### Uncertain function of light switch

Base model TT160CMX (below PNC's) can be involved.

**SERVICE INSTRUCTIONS:**

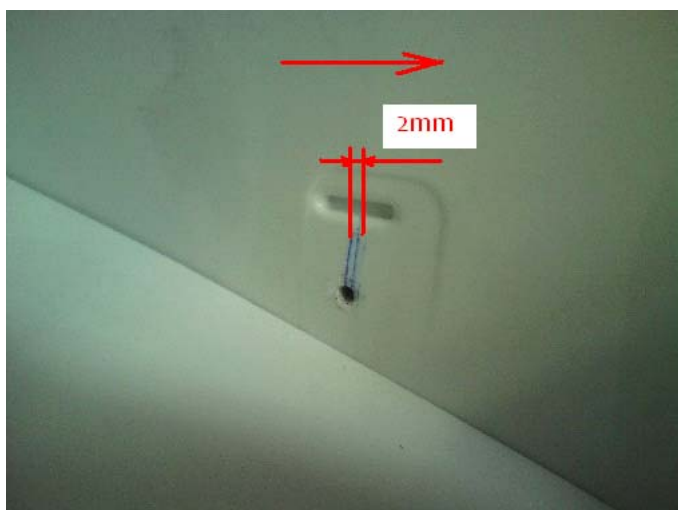
During the use of the appliance the Consumer can experiences uncertain switch off function of the light switch unit. That due to the relative position of the light switch unit with the door.

1. Check the safety lamp unit function. Measure the distance between side panel and door panel when lamp light on/off:
  - a. Over or equal to 40mm = OK
  - b. Less than 40mm = NOT OK; It's needed to modify the lamp unit position according to following instructions

2. Loose the light switch at front screw

3. Put a mark to the inner liner where to move the light switch (2 mm forward from the original hole position)

4. With a hand driller (D=3mm) carefully enlarge the hole in the inner liner

5. Fit into the hole the end of a simple tool (d max. =2,5mm )

With the help of a small hammer make an oval hole in the inner liner and move the threaded sheet (found behind the inner liner) 2 mm forward

6. Fix the lamp unit
